From: [Elnaz Mokhtari](#)
To: **S.33(1)**
Cc: [Hector Catalogna](#); [Stephen Muldoon](#)
Subject: RE: 42 James Street, Northcote, New Revision for Geotechnical Report (281686)
Date: Friday, 16 December 2022 12:25:24 PM
Attachments: [image003.png](#)
[image004.jpg](#)
[image005.jpg](#)
[image006.jpg](#)
[image007.png](#)
[image008.png](#)
[image009.jpg](#)
[image010.jpg](#)
[S44580_281686_IFC - Total.pdf](#)
[2201223-FEATURE.pdf](#)
[2201223-FEATURE.zip](#)

Please find attached a preliminary copy of the Civil Longitudinal section for the proposed spoon drain for the permanent batter for the land behind 42 James Street in Northcote. I have issued these for your review and comment.

PERMANENT BATTER REINSTATEMENT DETAIL

CLIENT City of Darebin	DESIGNED EM	DRAWN EM
PROJECT TITLE PERMANENT BATTER REINSTATEMENT DETAIL	CHECKED HC	No. OF SHEETS
SITE ADDRESS 42 James Street, NORTHCOTE, VIC 3070	SCALE NTS @ A1	DATE STARTED
DRAWING TITLE DETAILS	SITE ID & JOB No. S44580-281686	REV. B
	DRAWING No. S11

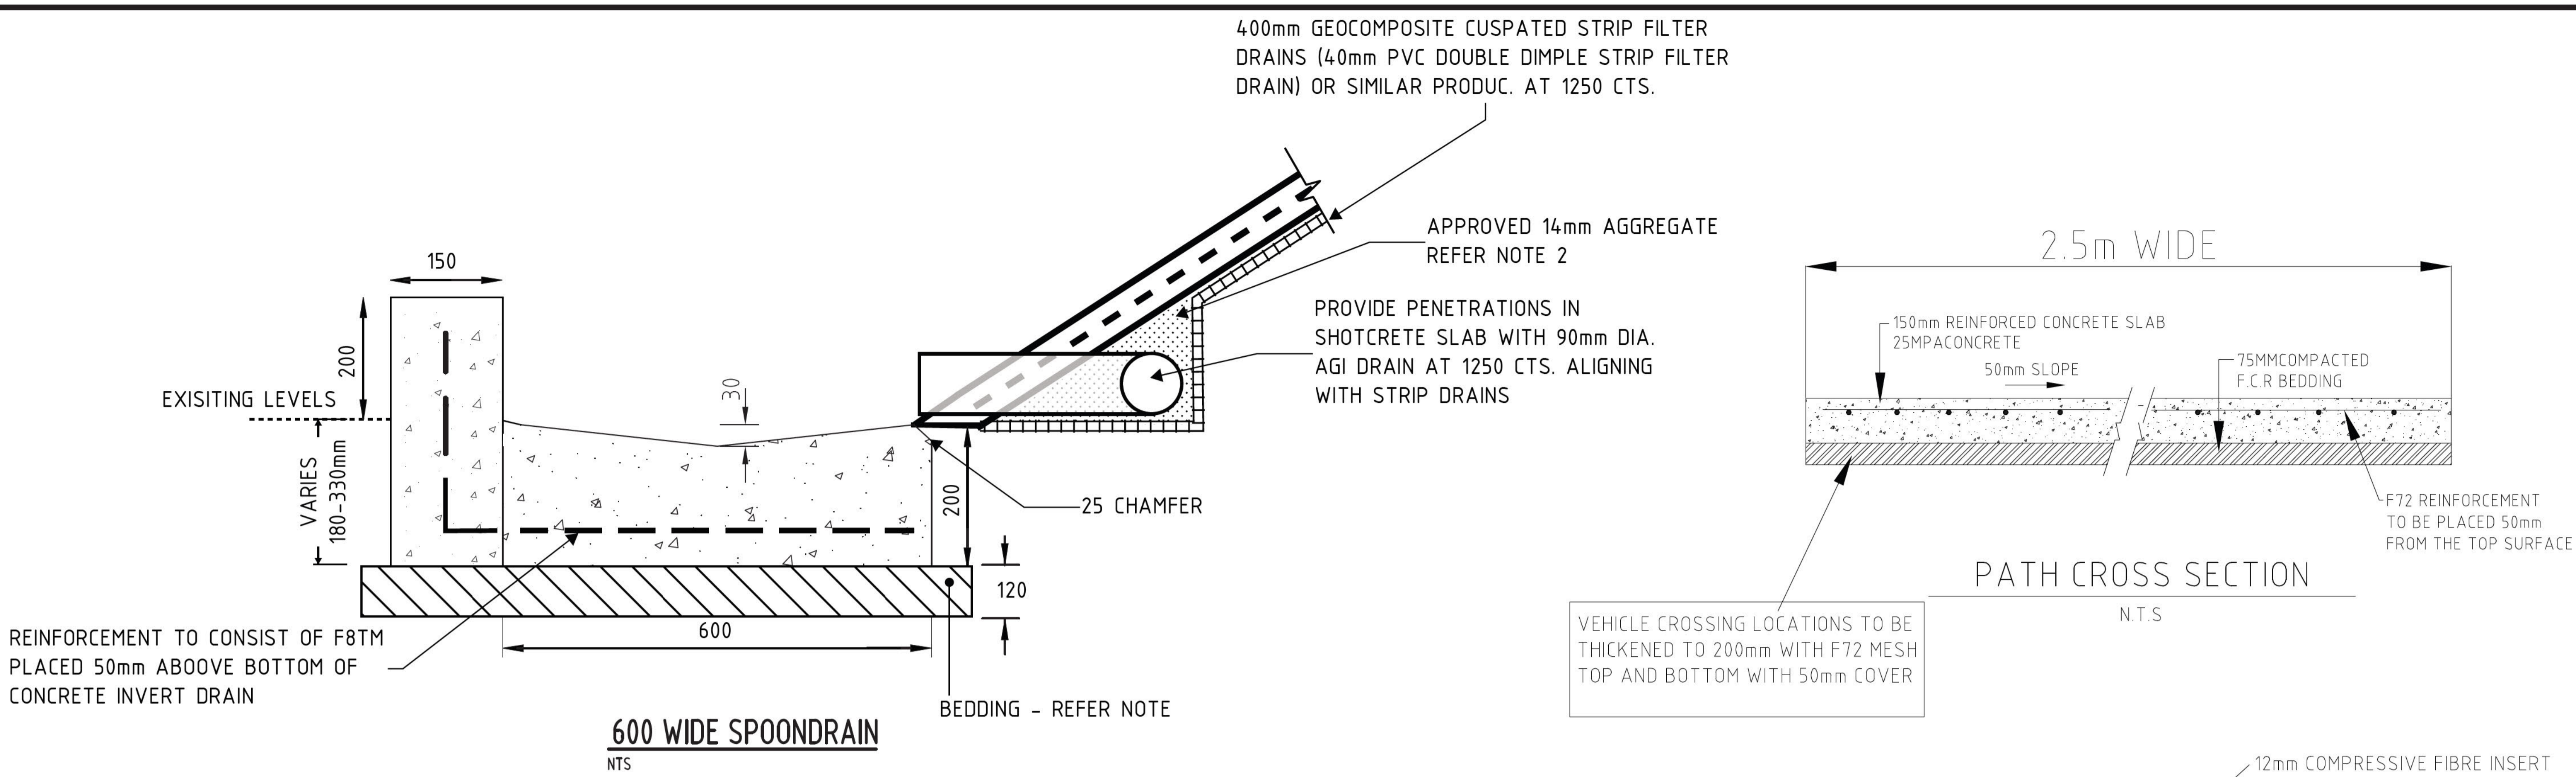
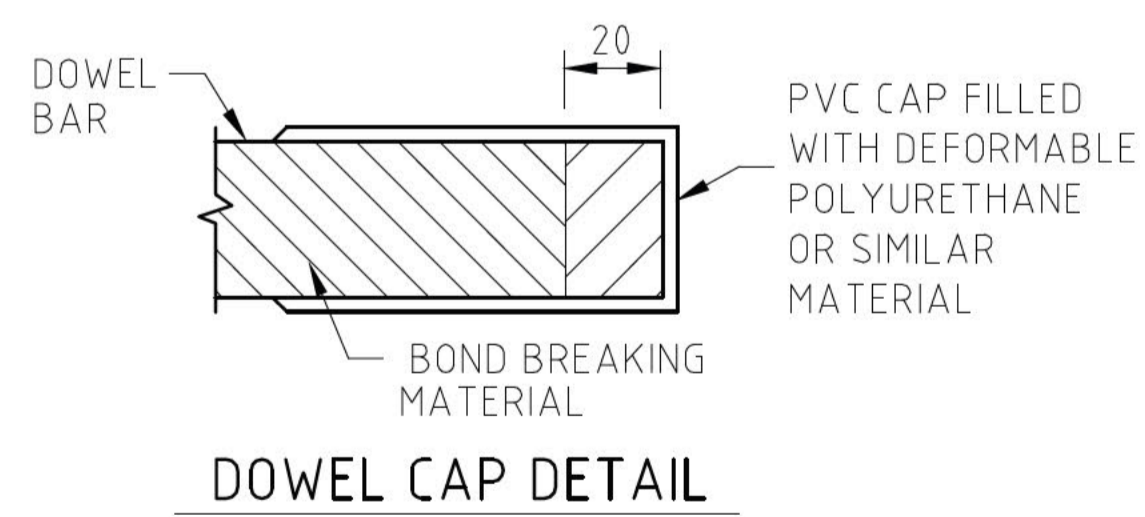
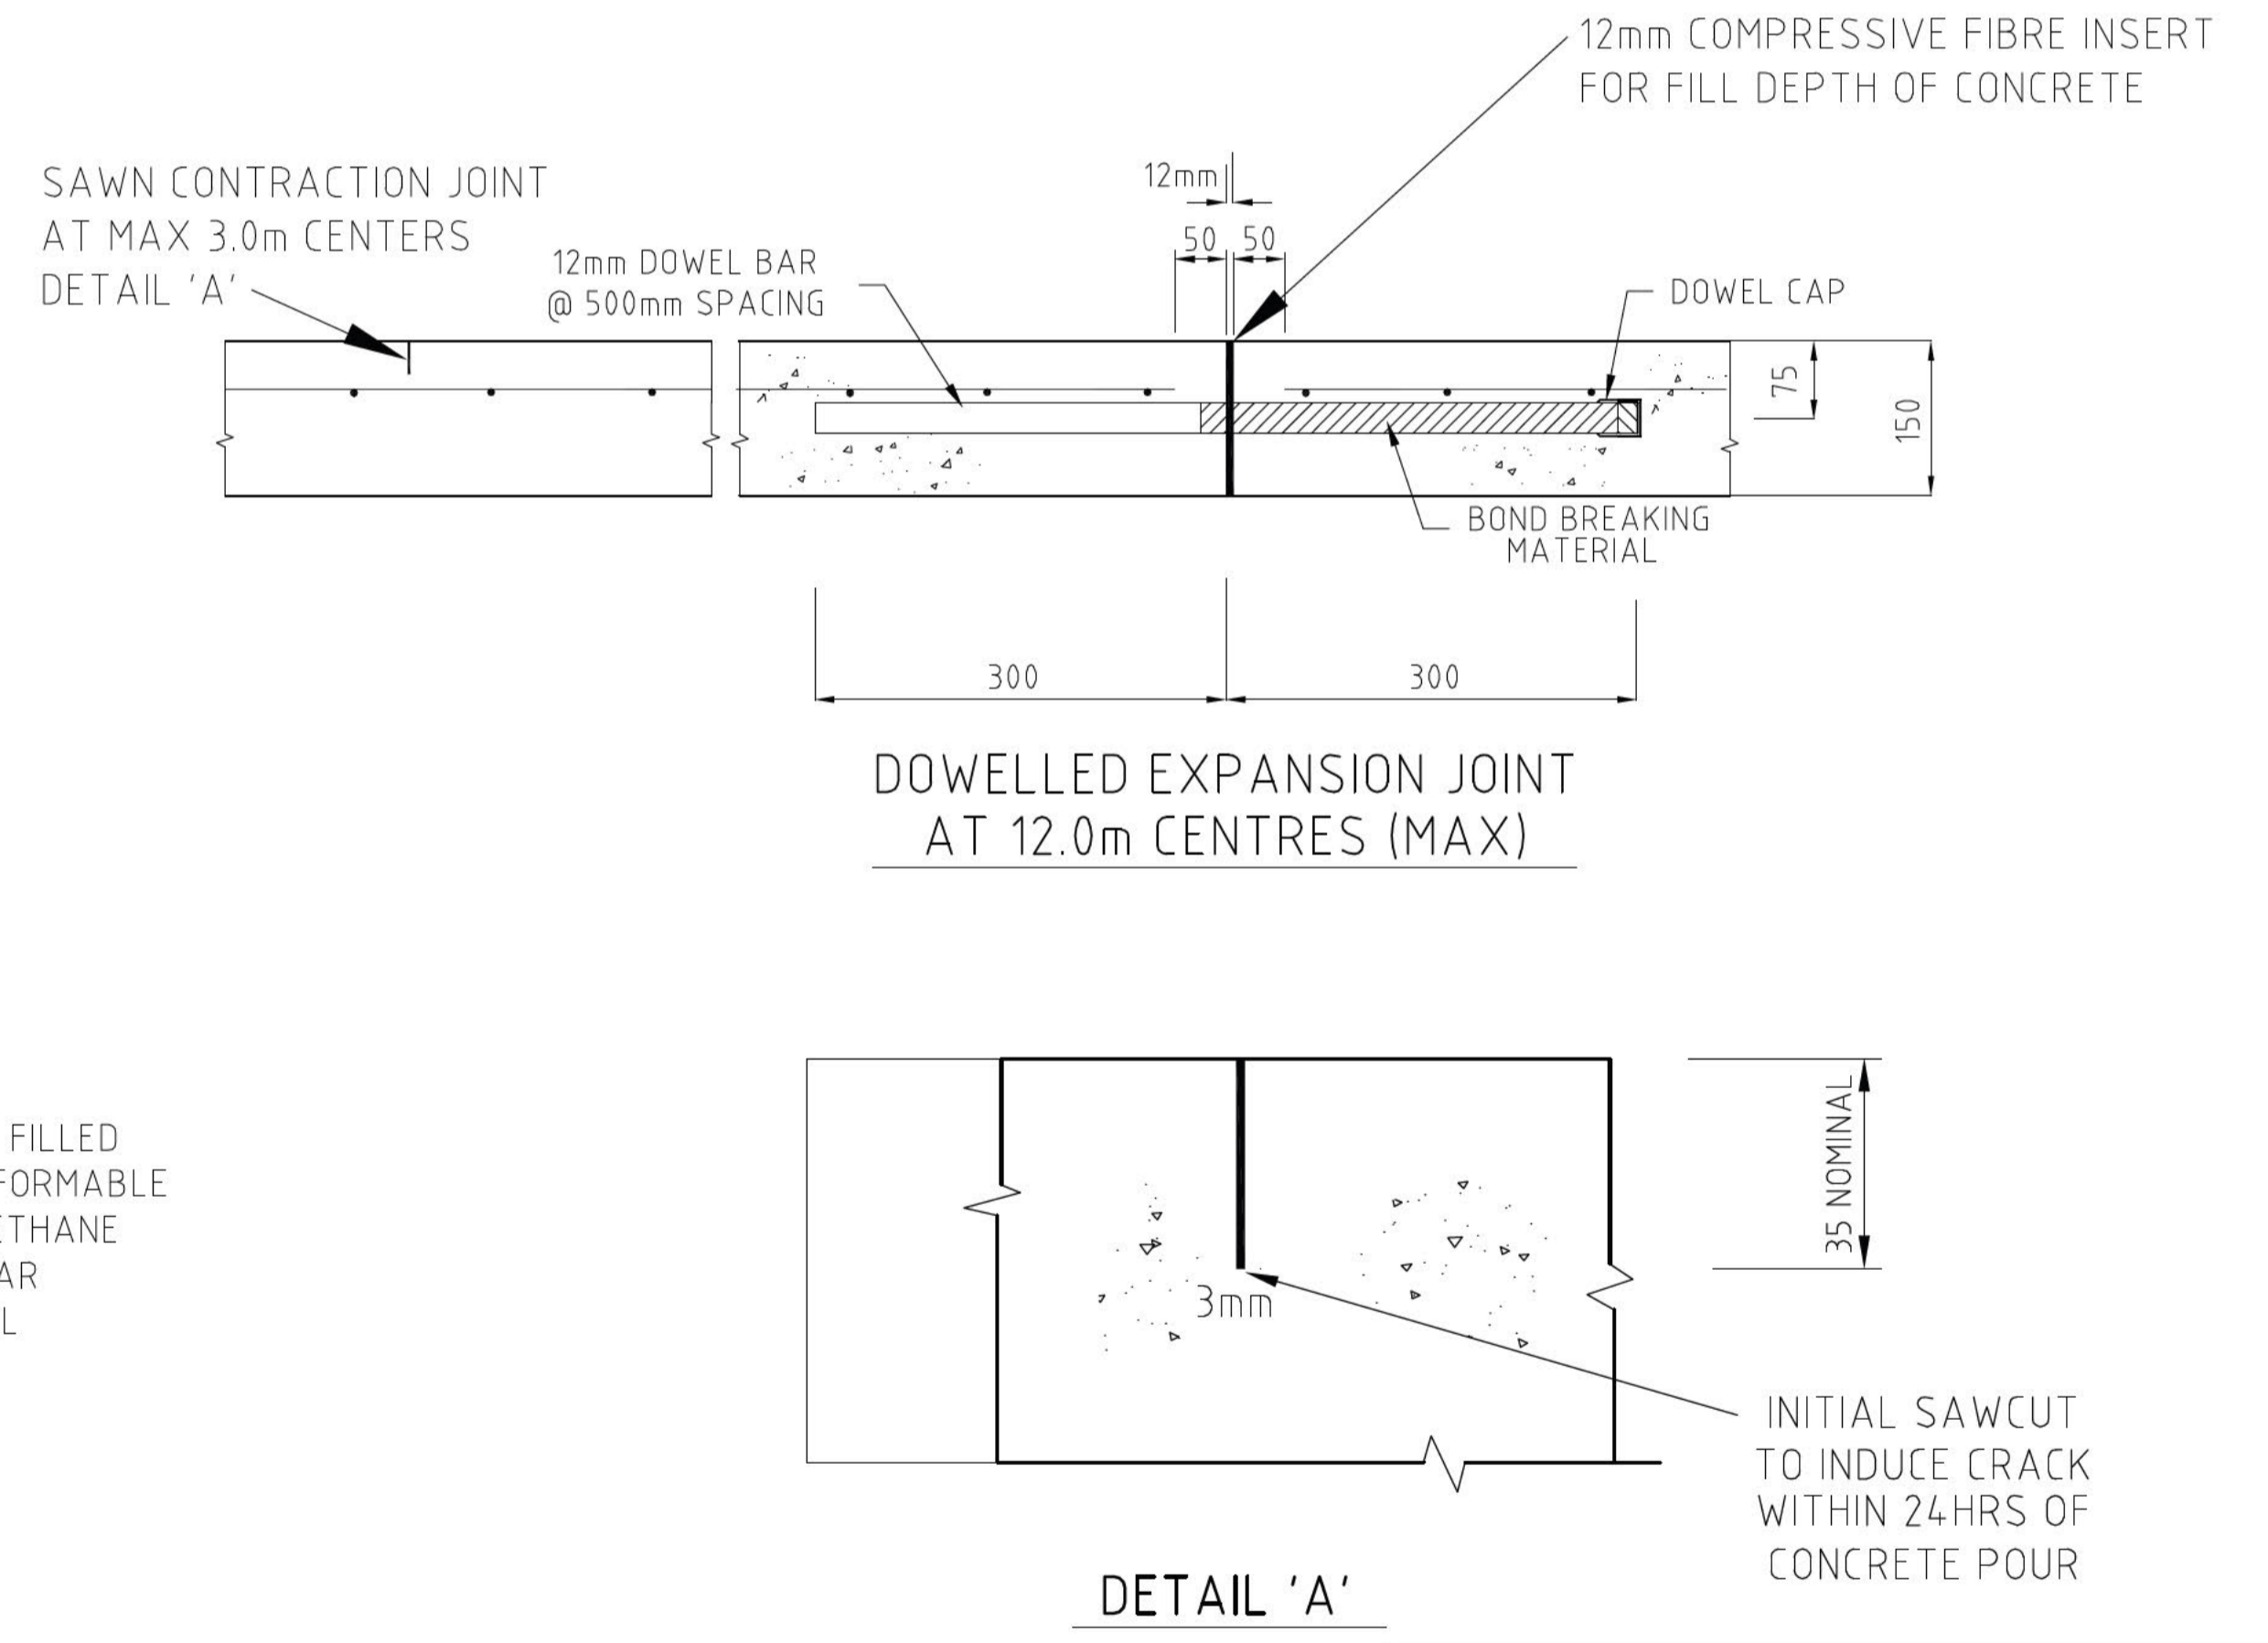
3. All details need to be consistent with Darebin Standard drawings. (attached).
As this is not a 'standard' project, the detail needs to be modified to suit site conditions/restraints i.e. the upstand barrier kerb. However, FMG can revise the spoon drain to align with the 600mm open invert drain detail if desired by the City of Darebin.

6. Bedding under spoon drain to be 120mm minimum depth Class 3 20mm size crushed rock as per Darebin standard.
This note can be added on the Civil/Structural drawings as required.

3. Details of the French drain to be added.

French drain has been changed to spoon drain and detail has been added

Refer spoon drain detail
